Bylong Coal Project

Response to Submissions on Groundwater

Prepared for
Hansen Bailey Pty Ltd

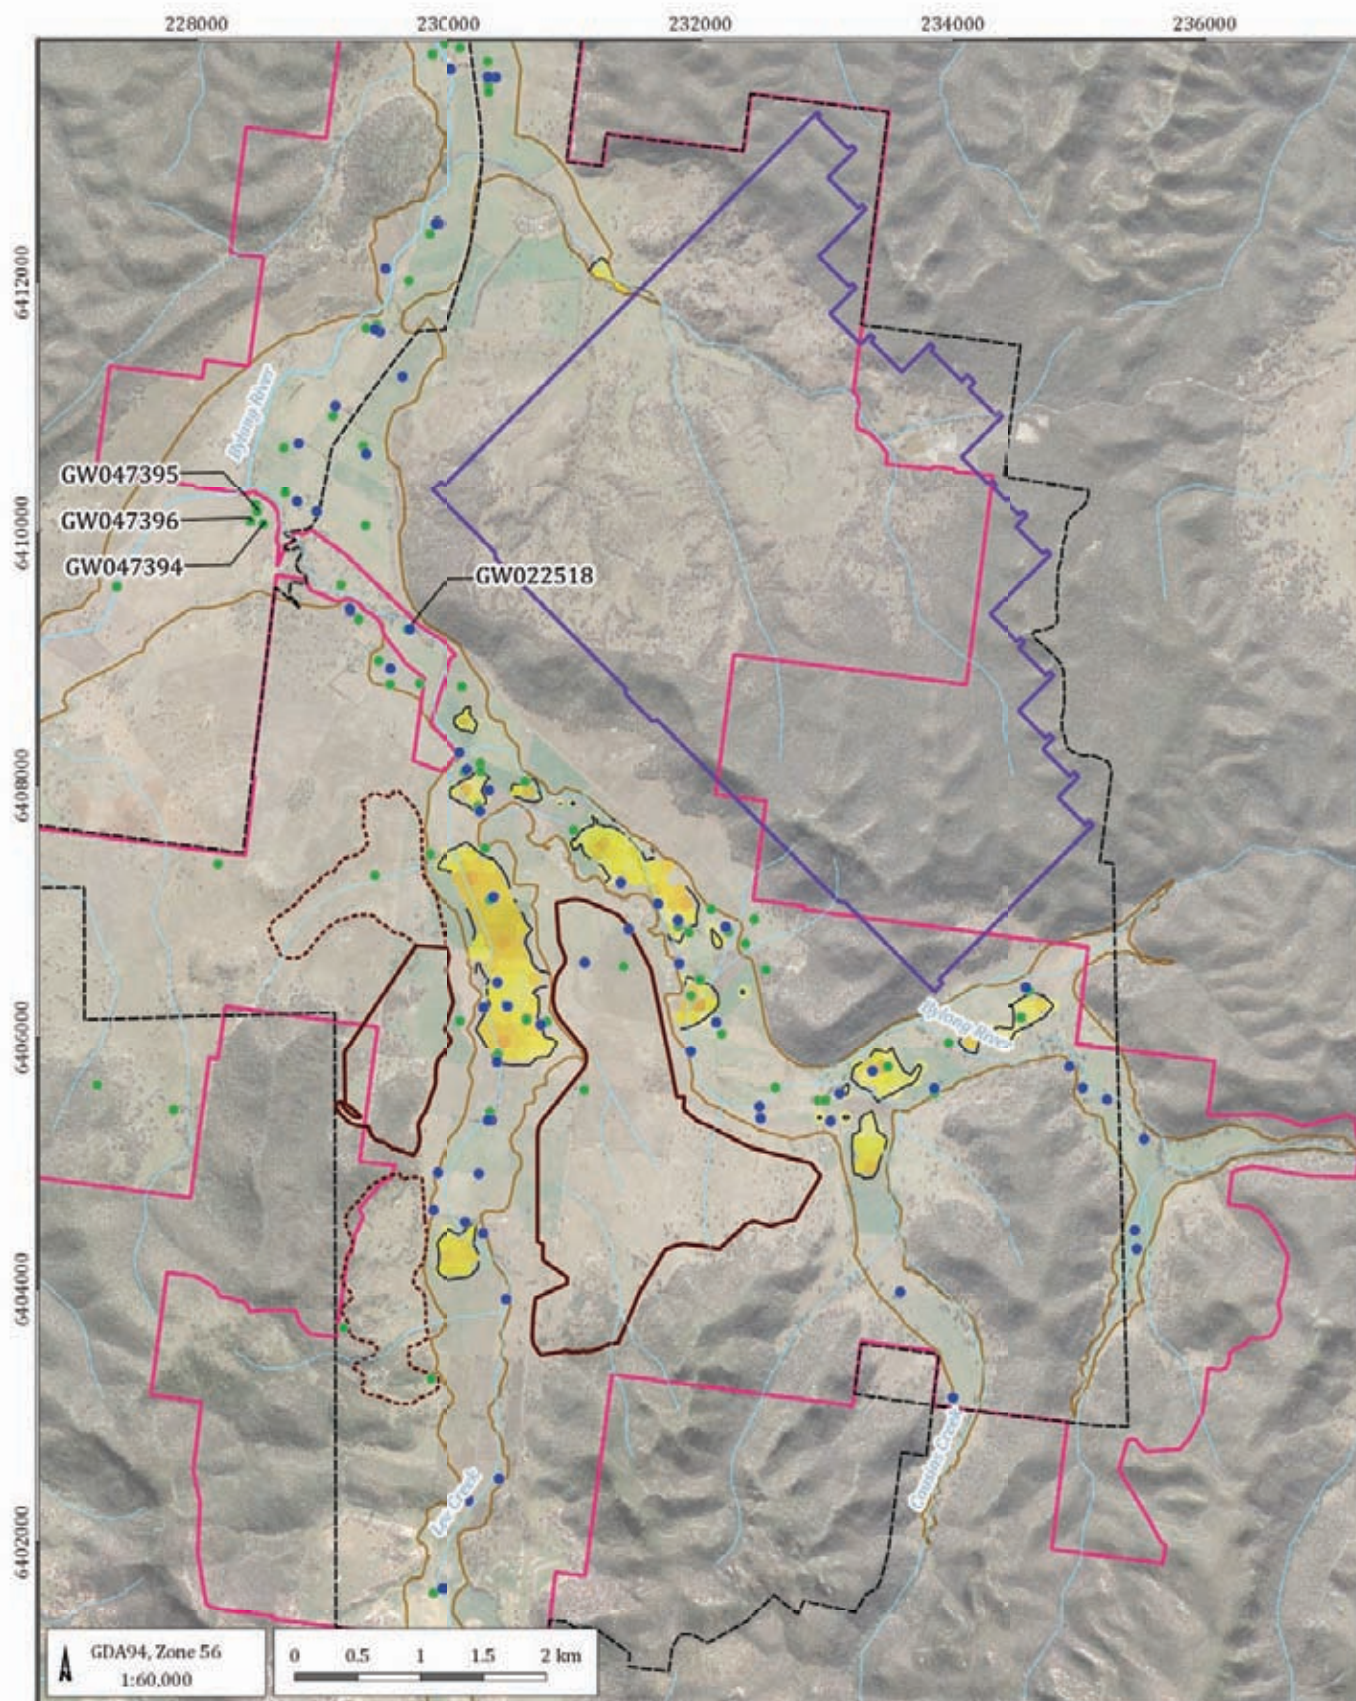
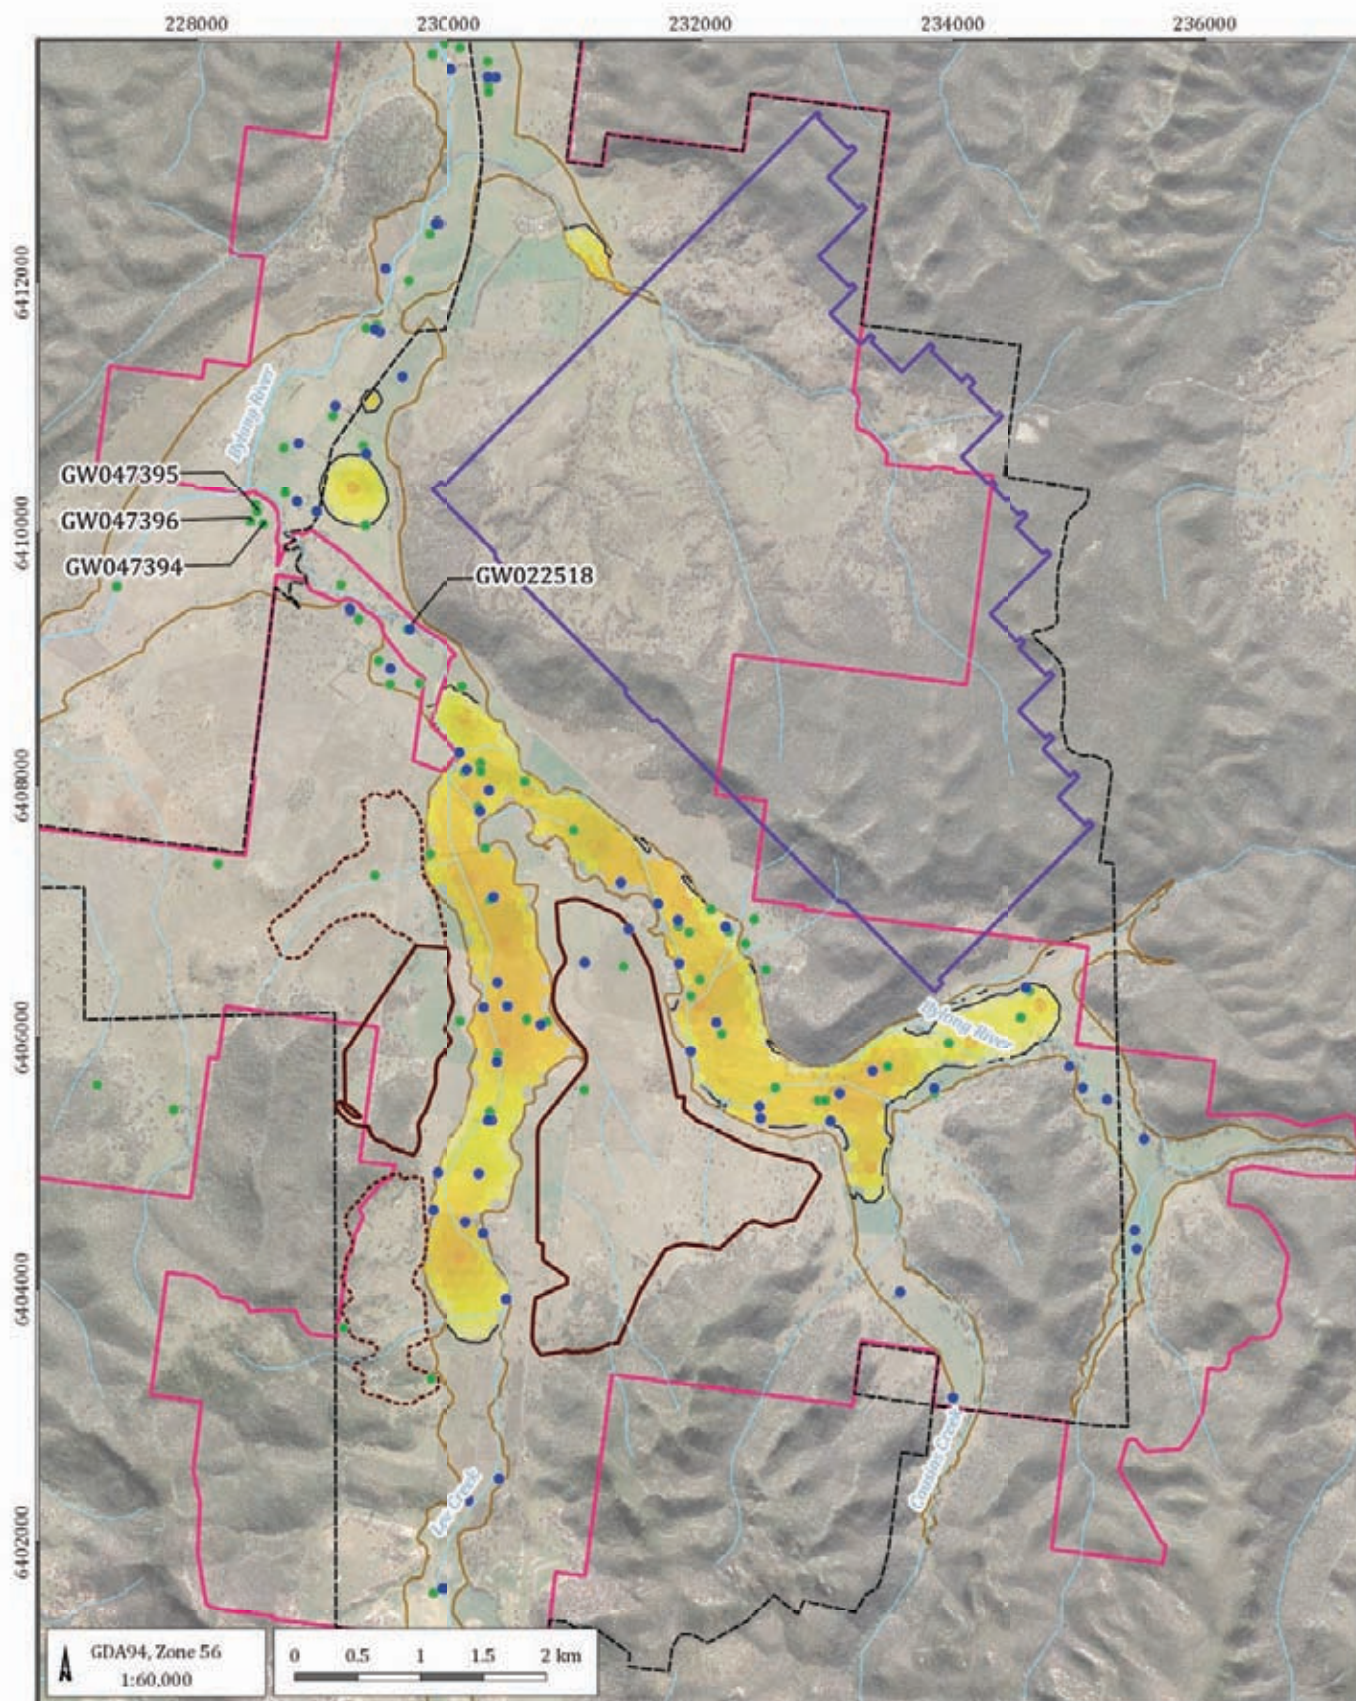
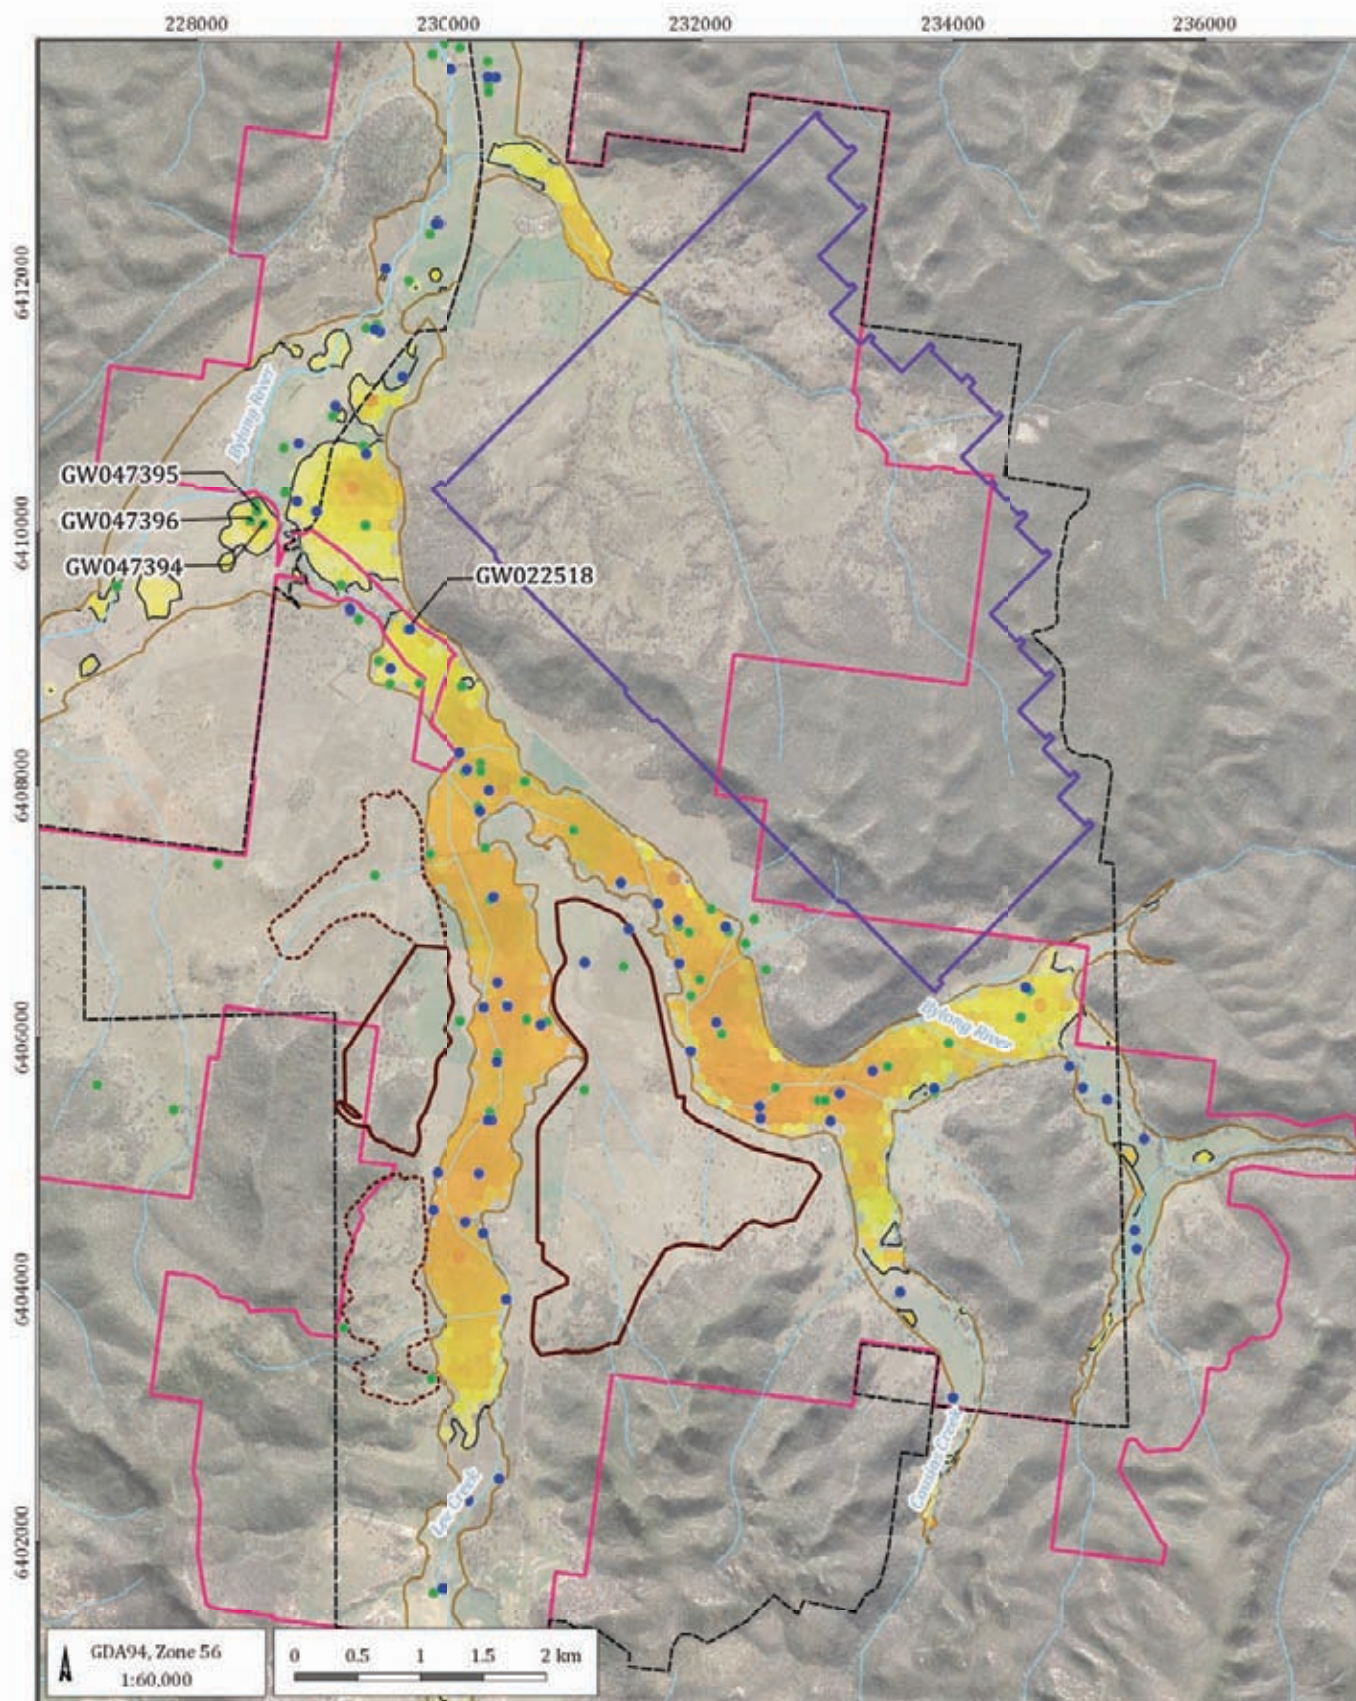
A number of stakeholders commented the hydraulic properties used to represent the Permian strata and requested modelling with alternative combinations of parameters. The following additional sensitivity analyses were undertaken:

- reducing the specific storage in the Coggan coal seam to $2 \times 10^{-5} \text{ m}^{-1}$;
- increasing the specific storage in the colluvium to 0.001;
- reducing the contrast between the vertical and horizontal hydraulic conductivity of the Triassic and Permian rock units to a minimum of two orders of magnitude; and
- increasing the contrast between the vertical and horizontal hydraulic conductivity of the Triassic and Permian rock units to one order of magnitude.

Figure 43 to Figure 45 shows the maximum drawdown predicted by the model within layer 2 (alluvium) for the above scenarios. The figures illustrate the mean, and three standard deviations from the mean (0.1st and 99.9th percentiles) which are essentially the upper and lower boundary of impacts. Figure 46 shows the changes to drawdown that occurred in the model when changing the vertical hydraulic conductivity.
